Technical Update

Component identification and location information

The information in this update replaces the system-board component identification and location information in the IBM *@server* xSeries™ 305 Type 8673 documentation that comes with your server.

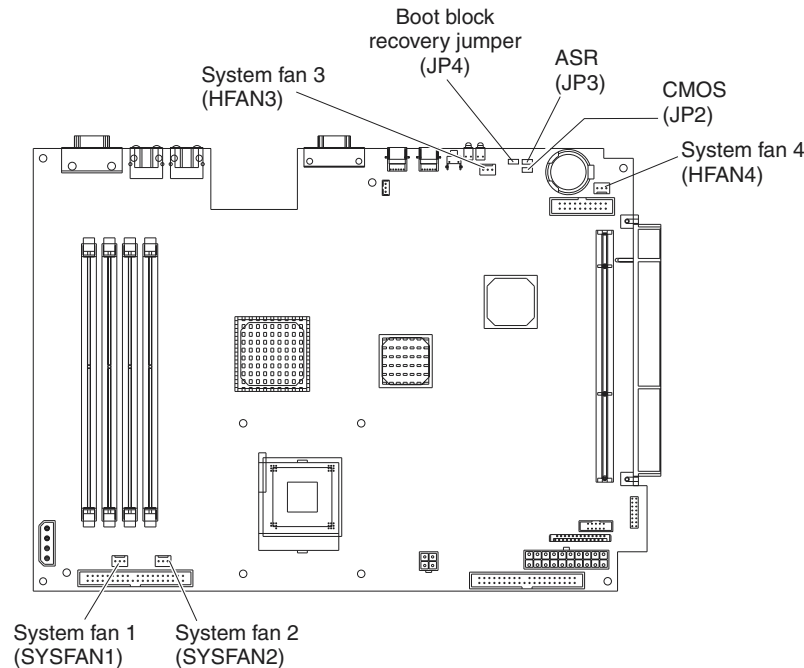
The following illustration shows only the system-board components whose identification or location is different from what appears in the documentation that comes with your server.

1. The Automatic Server Restart (ASR) jumper (JP3) causes the server to restart automatically if it stops (for example, if the operating system stops running). The default position of the jumper (ASR enabled) is pins 2 and 3.
2. The system board does not have a JP1 jumper as described in the documentation.
